**SUNDRY NOTICES AND REPORTS ON WELLS**

(other)  Reperforate, acidize, and treat Upper & Lower Gallup Sands

HORSESHOE GALLUP UNIT WELL #53  
SAN JUAN COUNTY, NEW MEXICO

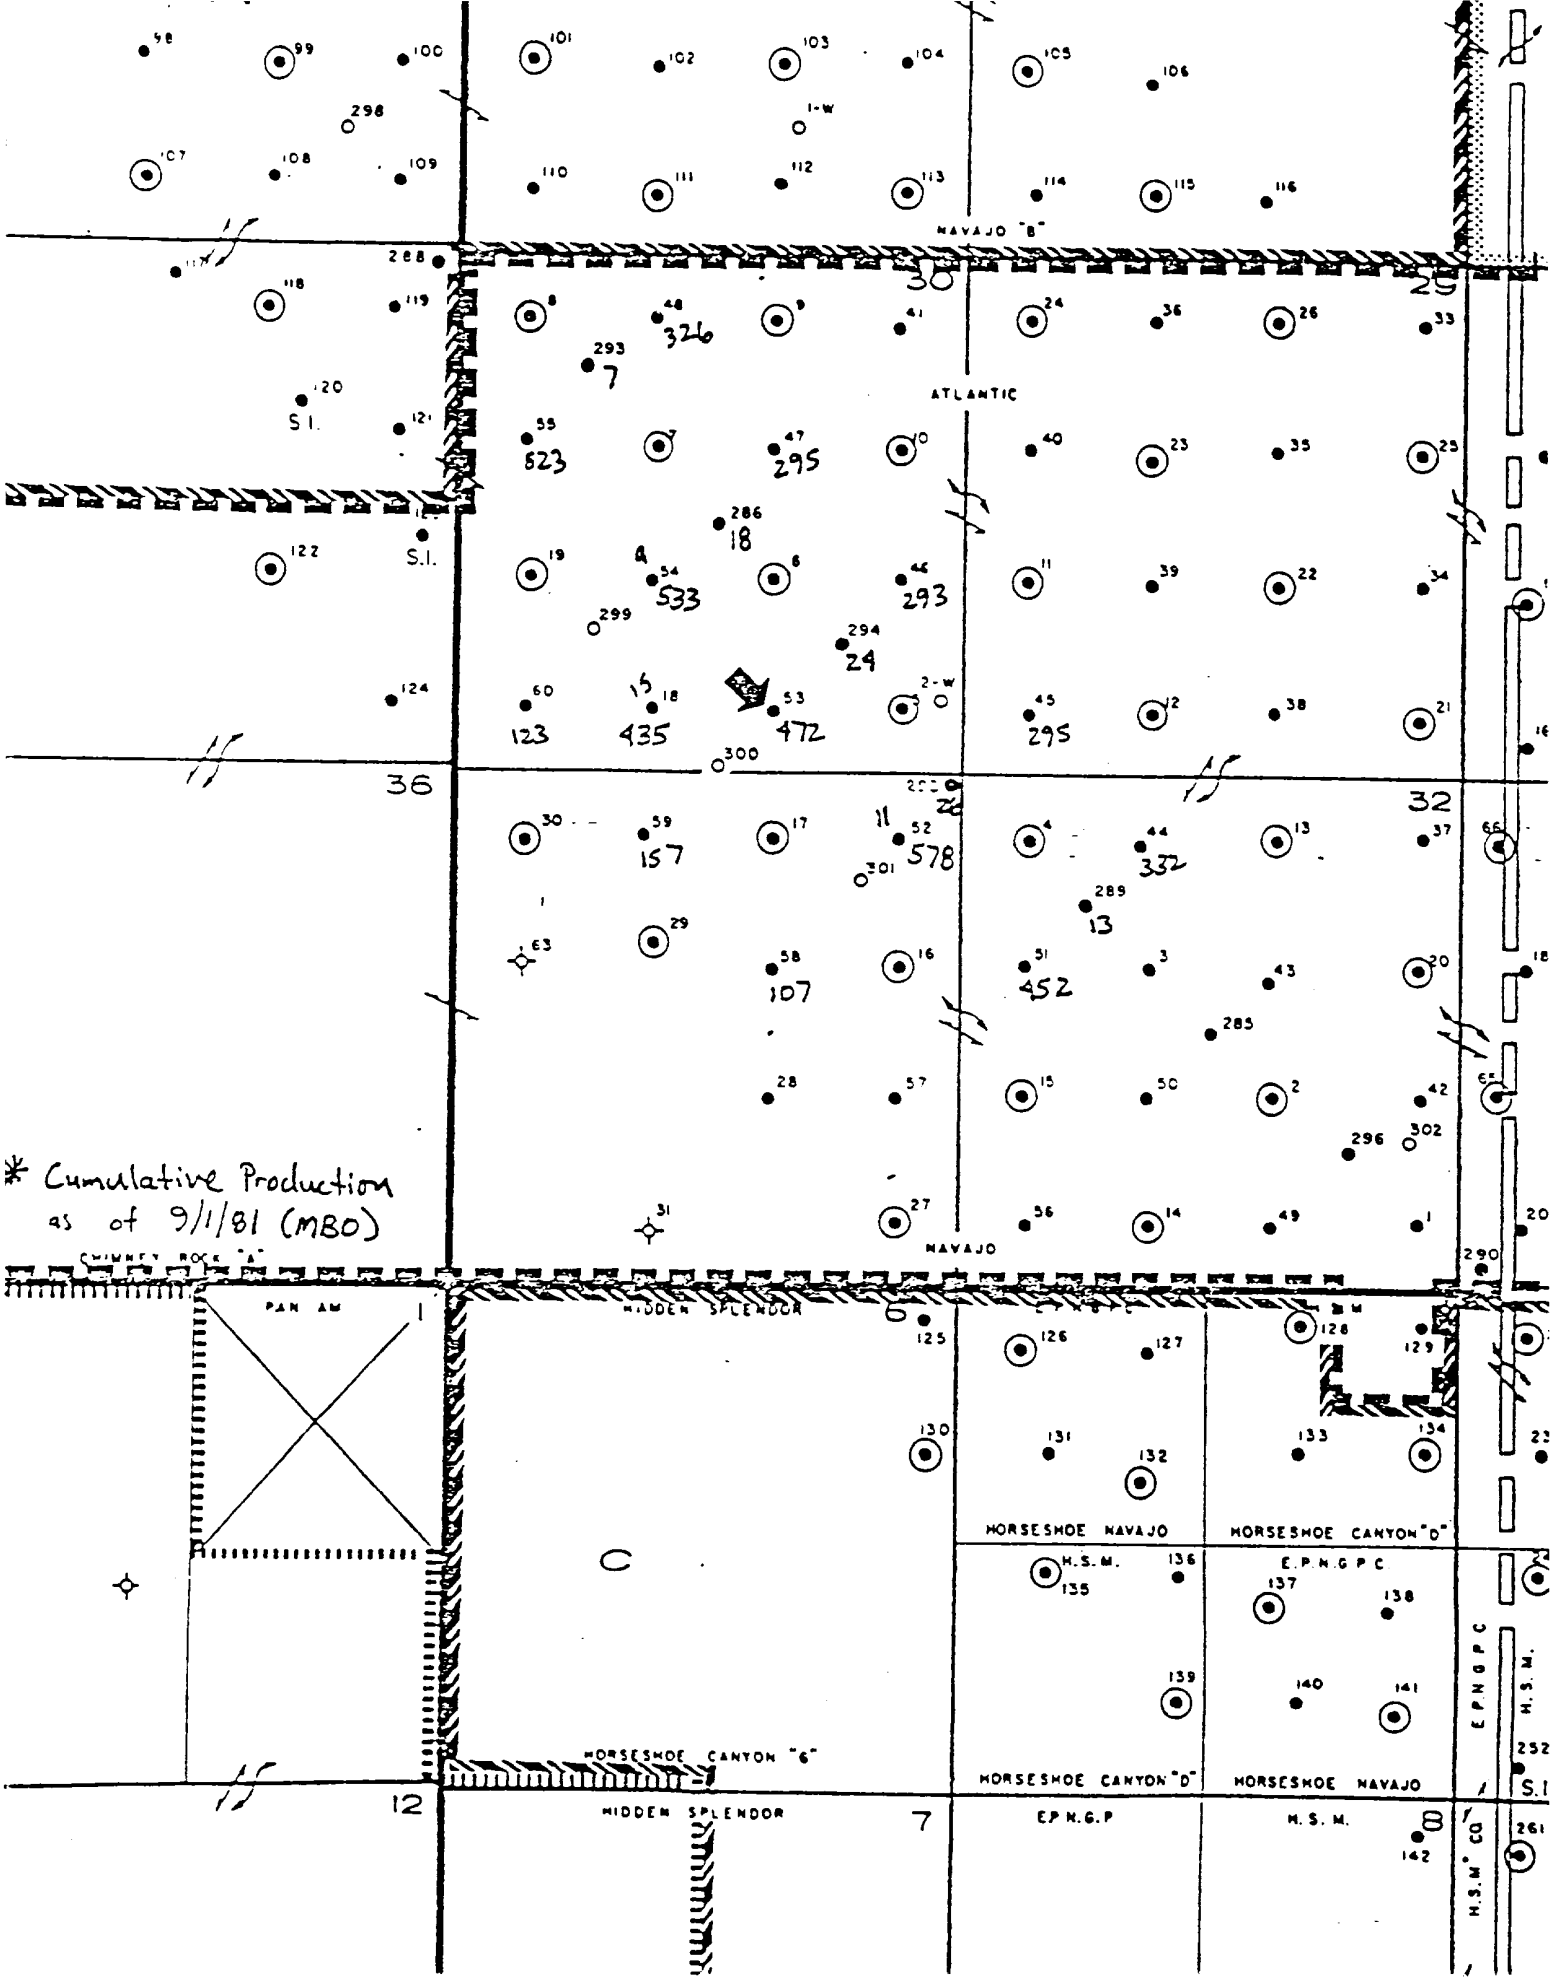
Workover Procedure: \* Casing leak must be repaired before well is produced. Notify this office by Sundry Notice of intent or plans to repair casing.
